Proposed Gull Service Station, Paraparaumu – Transportation Assessment.

ADDENDUM TO THE TRANSPORTATION ASSESSMENT REPORT

RESPONSE TO THE REQUEST FOR FURTHER INFORMATION

Figure 2: Proposed Amohia Street Site Access.

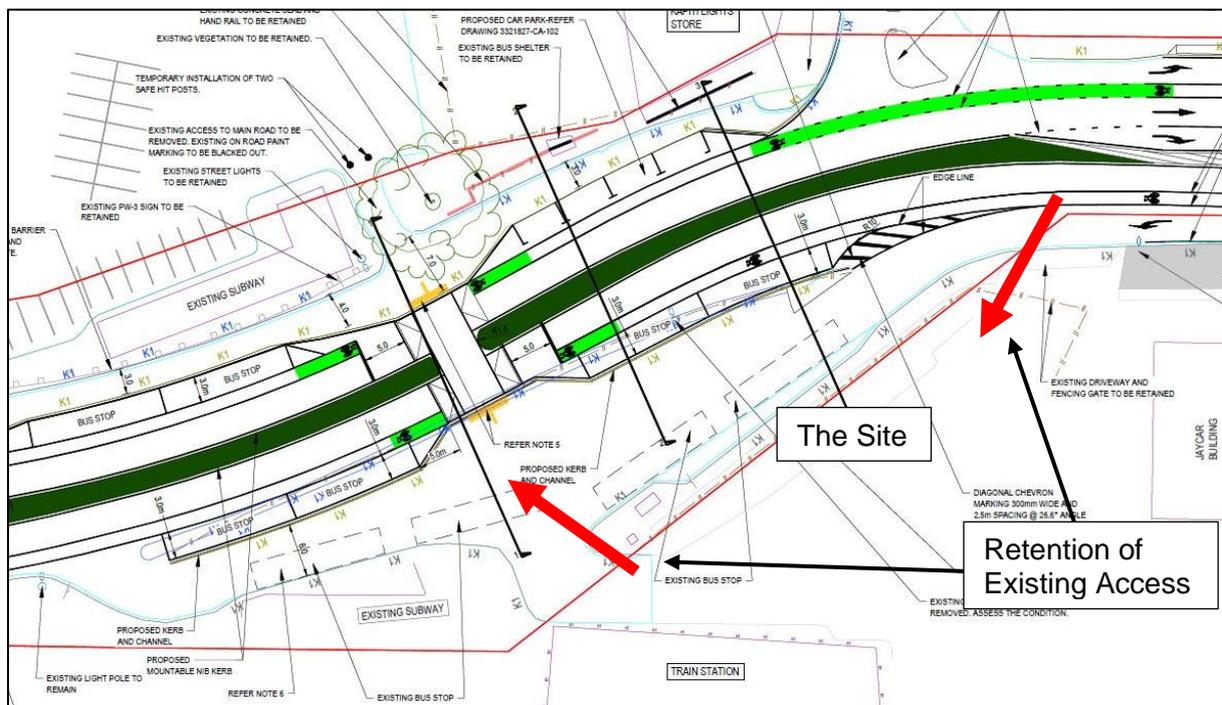
Since the transportation assessment report was prepared however, the design of the proposed improvements to Amohia Street has changed. Whereas the original design included the provision of new, dedicated two-way access to the site with a left turn in slip lane and a left turn out, together with the closure of the existing access to the bus lay-by area, the latest plans show the retention of both the existing northern access to Amohia Street and the existing southern access to the bus lay-by area. The latest design is shown on the following figure.

Figure 2 shows the proposed retention of both the existing stop vehicle crossing adjacent to the Jaycar site and the existing access adjacent to the railway station.

The proposed access to the service station has been updated in accordance with the latest design, as shown above. As the existing access adjacent to the Jaycar site will be from the left turn slip lane, only the left turn in movement is proposed at this access. Similarly, as vehicle movement within the transport hub area is one-way southbound, only the left turn out movement will be permitted at this access.

not included on the drawings. This report however recommends that a standard vehicle crossing be provided at the entry to the site from Amohia Street and that a raised pedestrian threshold be provided at the exit to the bus lay-by area, with a detailed design that is consistent with the facilities being proposed as part of the revocation process.

Figure 3: Standard Drawing for Raised Crossings.

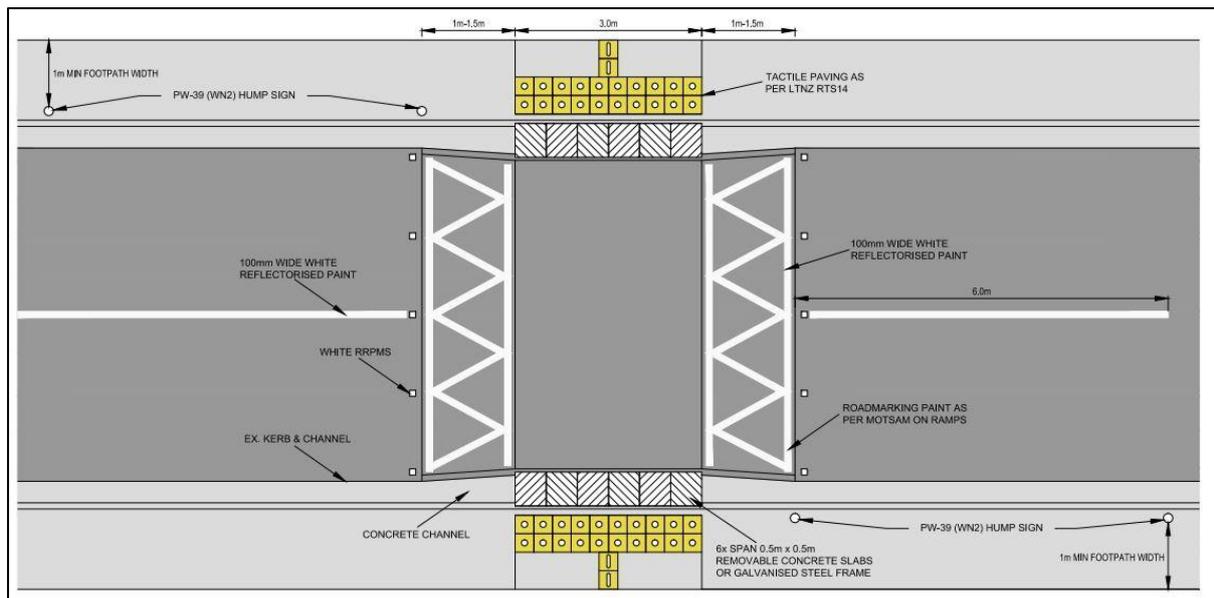
Figure 3 shows that the standard design has a 3.0m wide crossing, but without a contrasting pavement surface. To provide additional amenity for pedestrians, it is proposed that the crossing be constructed with a contrasting pavement surface. To ensure that vehicles travel across the threshold slowly, it is recommended that this threshold also be constructed with a minimum height of 100mm and with a slope of 1:10 on the ramps on each side of the threshold.

While Drawing RD-010 specifies a minimum 3.0m wide pedestrian platform, to provide additional capacity for pedestrians, it is proposed that a minimum width of 5.0m be provided, which will be consistent with the proposed Amohia Street crossing. The proposed crossing will then provide a similar pedestrian facility to that at the Amohia Street crossing however with significantly lower traffic volumes and without traffic signal control.

Figure 4: Pedestrian Visibility.

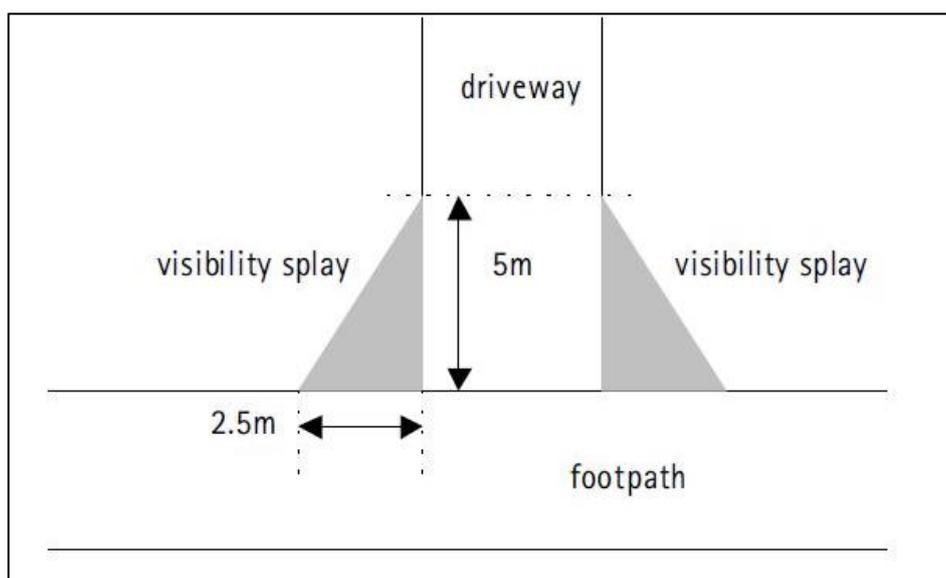
It is noted that the required pedestrian visibility shown on Figure 4 is of a higher standard than the similar requirements given in NZS2890.1:2004 "*Parking facilities Part 1: Off-street car parking*". The proposed design will provide visibility splays as required.

Design	BH	Job No.	CAD File	Z158
Drawn	JT	276	Plot Date	03.07.19
Checked	BH		Rev.No.	
Date	16.03.18	Drawing No.	276-01	1
Drawing	1 of 8

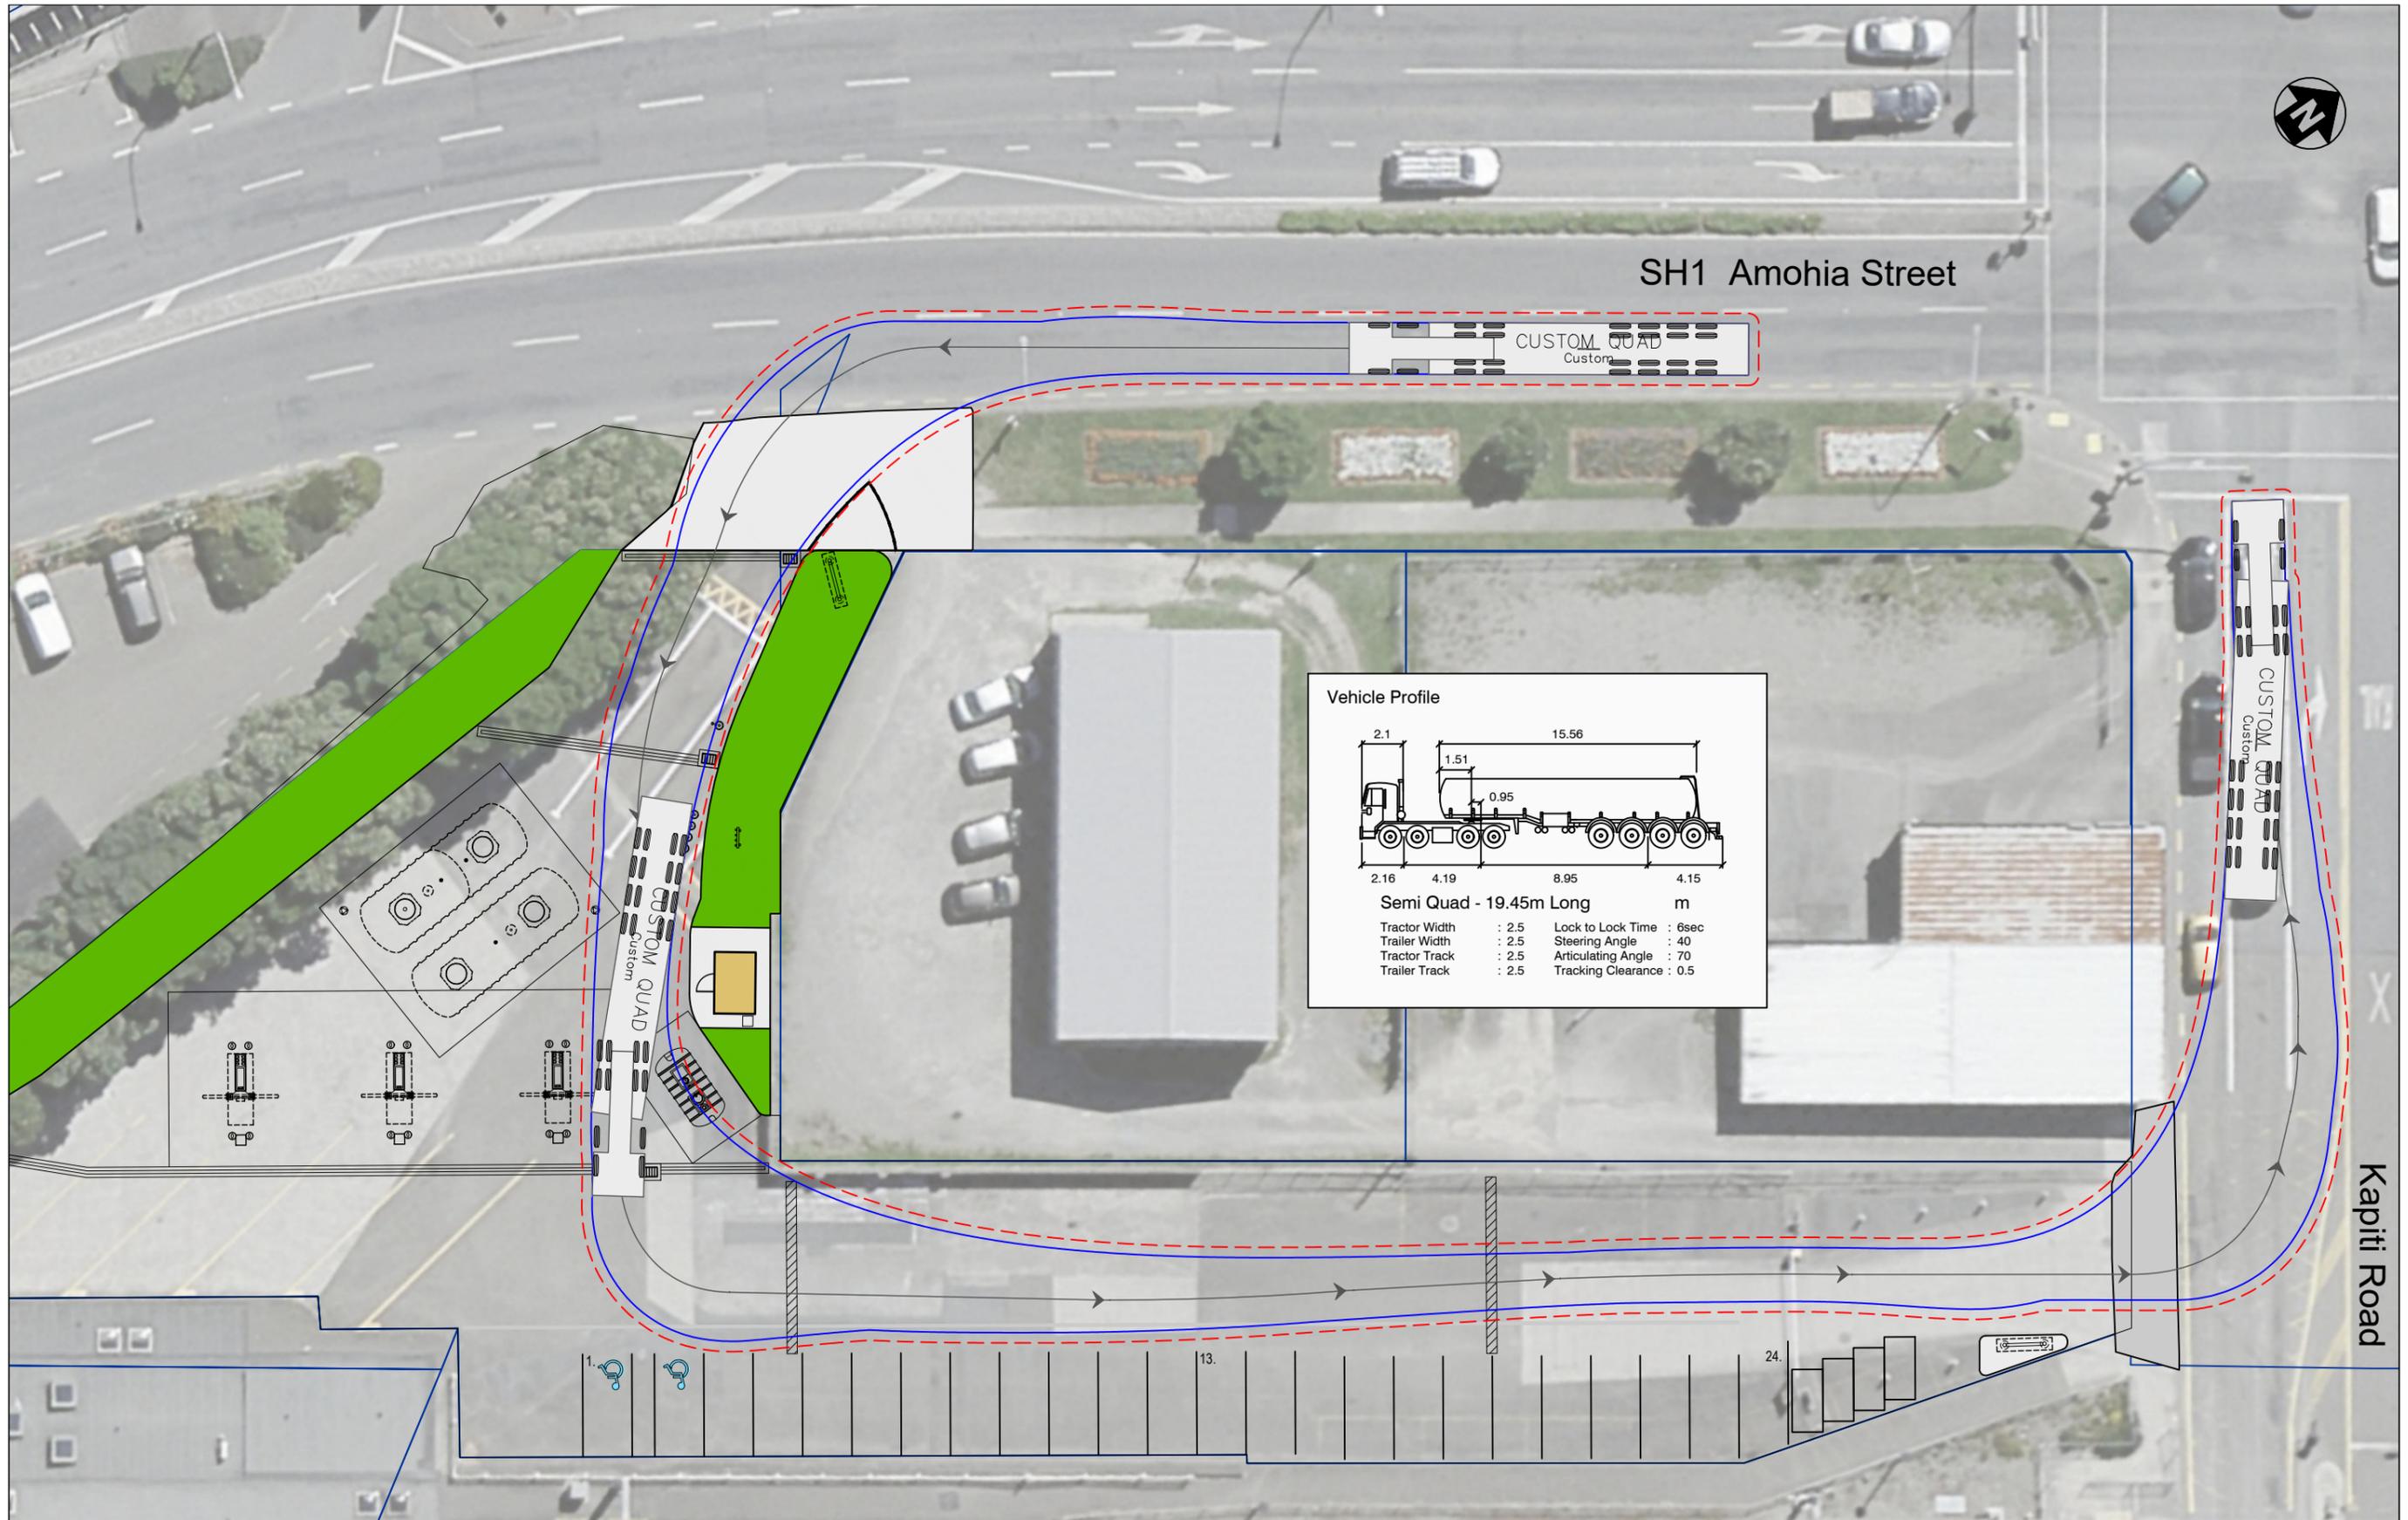
As previously, fuel tankers are proposed to turn left onto the site from the Amohia Street northern vehicle crossing and exit the site to Kapiti Road. The tracking of the design fuel tanker is shown on the attached Drawings 1 and 2. These show that the manoeuvring can be accommodated and that the fuel tanker is able to exit the site in a forward's direction.

Council has identified instances where the tracking of tankers appears to over-run the median. The drawings have been prepared using pdf copies of the drawings as provided by Council. For improved accuracy, a copy of the drawings is required in dwg format. While drawings in this more accurate format have been requested, NZTA has declined to provide copies.

Council are also concerned about tankers crossing the cycle lane on entry to the site. Revised tracking is attached that shows the fuel tanker crossing from the through traffic lane onto the left turn lane and keeping within the dashed continuity lines, as permitted.

Revised tracking is attached that shows the fuel tanker crossing from the through traffic lane onto the left turn lane and keeping within the dashed continuity lines, as permitted.
